0	ADDENDUM 1	10/02 2020
revisions		date
project		project

552613
ATLANTIC INSTITUTION
HEATING PLANT UPGRADE

BOILER ROOM PLAN
BOILER PIPING
NEW LAYOUT

drawing no. / no. du dessin
SKH-01

BOILER ROOM PLAN
BOILER PIPING NEW LAYOUT
 SCALE : 1:50

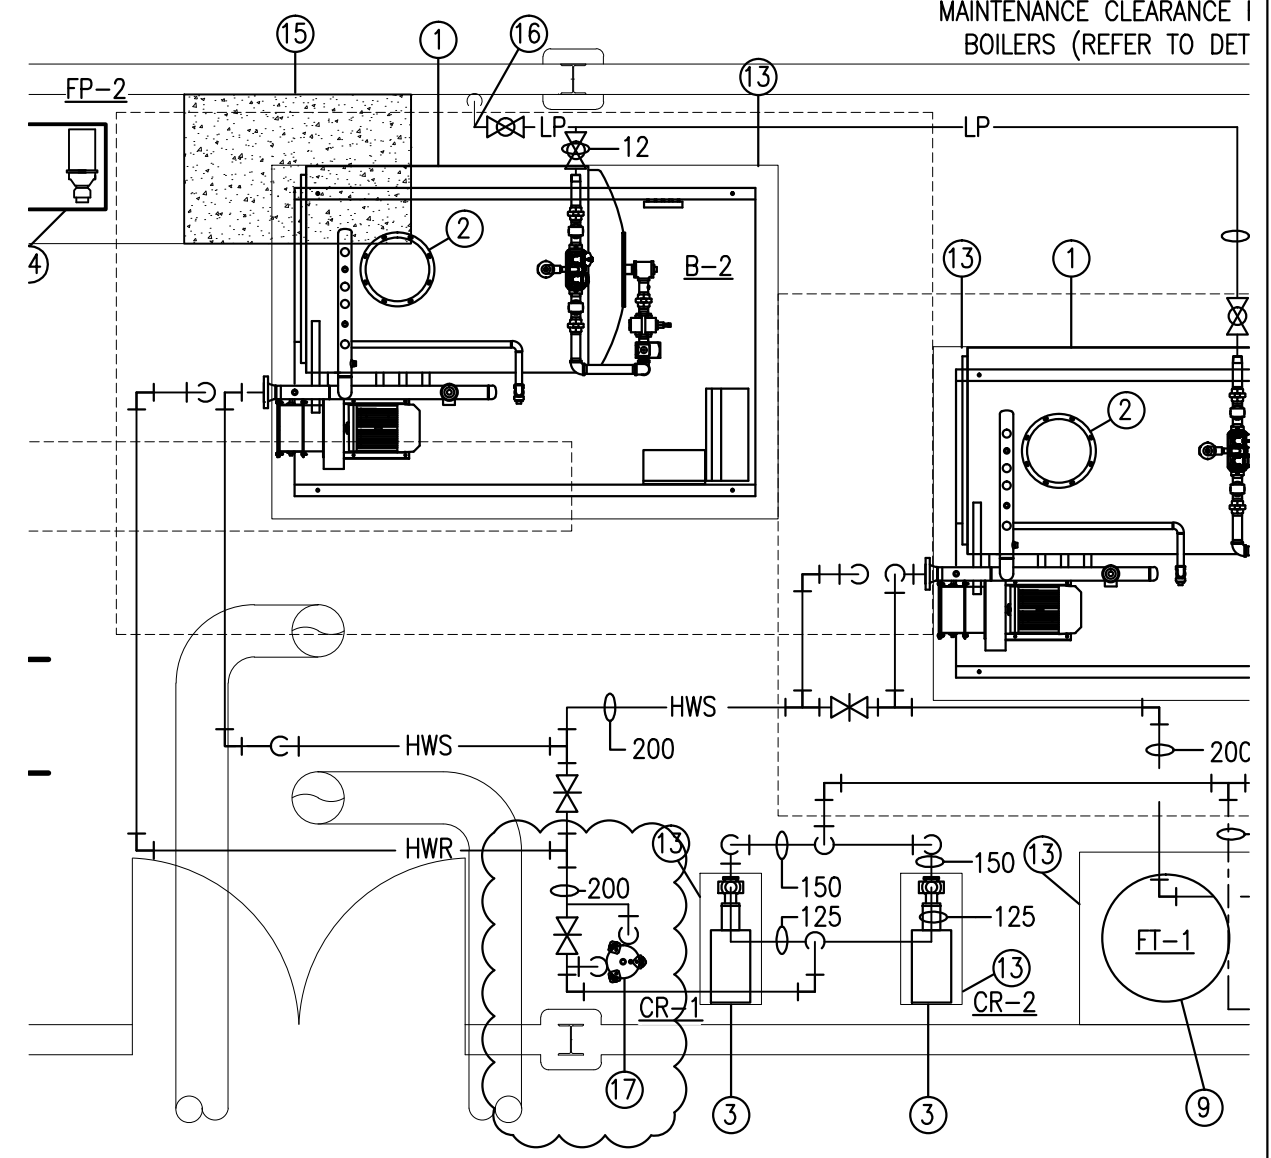
- ⑮ REMOVE SECTION OF EXISTING CONCRETE PAD AS SHOWN TO ACCOMMODATE NEW BOILER HOUSEKEEPING PAD IN THIS LOCATION.
- ⑯ CONNECT NEW LP GAS PIPING TO EXISTING PIPING IN LOCATION SHOWN. PIPE TO EACH BOILER FOR BURNER PILOT OPERATION.
- ⑰ NEW CHEMICAL BY-PASS FEEDER
